County of Santa Clara

Department of Planning and Development

FILE NUMBER: PLN21-114
SUBJECT: Building Site Approval on Slope 30% or Greater and Special Permit
SITE LOCATION: 0 Helen Way, Los Gatos, CA, 95033 (APN: 544-39-035)
DATE RECEIVED: June 20, 2023 (resubmittal)

Fig. 4.20-2
Parking Structure
—Sloping Lots

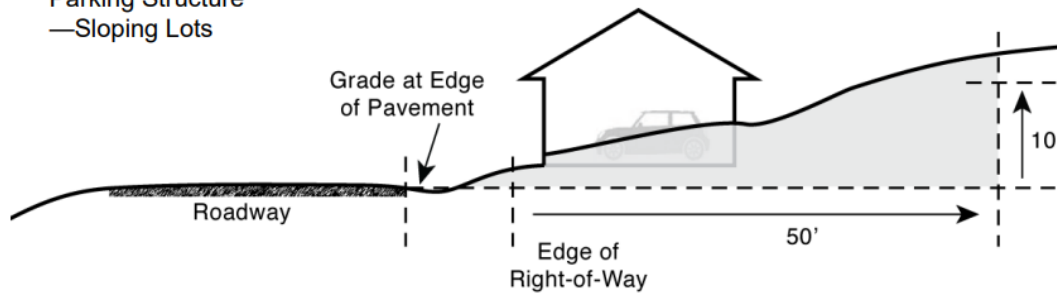
6. Although the required setback lines are not clearly identified on the site plan, it appears the proposed detached garage might encroach into the required front setback. Please note, a setback-exempt structure may be granted through a Special Permit to accommodate unusual circumstances pursuant to Zoning Ordinance 4.20.020.(F). If the proposed detached garage encroaches into the required front setback, please provide the information below and apply for a Special Permit with filing fees.

- a. A section drawing cutting through the Redwood Drive roadway and the proposed garage. The section cut shall extend a minimum of 50-feet beyond the edge of the right-of-way. Pursuant to Zoning Ordinance 4.20.020.(F).(1), “Where the grade elevation at a point 50 horizontal feet inward from the edge of right-of-way differs 10 vertical feet or more from the elevation at the adjacent edge of pavement, a garage, carport or other parking structure may be located within the required front or side yard of a lot.” (see Fig 4.20-2 inserted from Zoning Ordinance).
